# UNITED STATES PATENT AND TRADEMARK OFFICE

APPLICATION NO.	FILING DATE	FIRST NAMED INVENTOR	ATTORNEY DOCKET NO.	CONFIRMATION NO.
10/705,680	11/10/2003	Hyeong-Geun An	5649-1197	4655
20792	7590	10/03/2005	EXAMINER	
MYERS BIGEL SIBLEY & SAJOVEC			TRAN, LONG K	
PO BOX 37428			ART UNIT	
RALEIGH, NC 27627			PAPER NUMBER	
			2818

# Office Action Summary

FIG. 2'

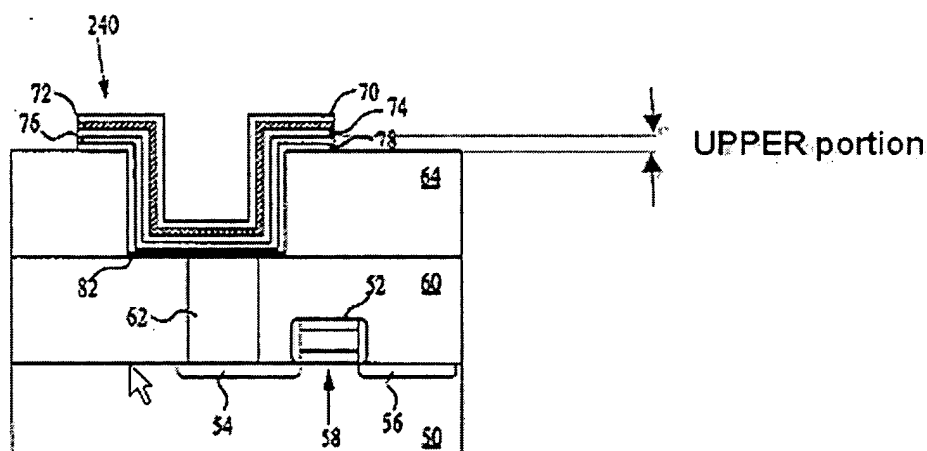
Regarding claim 3, Agarwal discloses the lower electrode 76/78 includes an UPPER portion (broadly interpreted; examiner's modified drawing fig. 2') thereof extending from the trench to a height relative to the integrated circuit substrate greater

than a height of the support insulating film and wherein the seed conductive film covers the upper portion of the lower electrode extending from the trench.
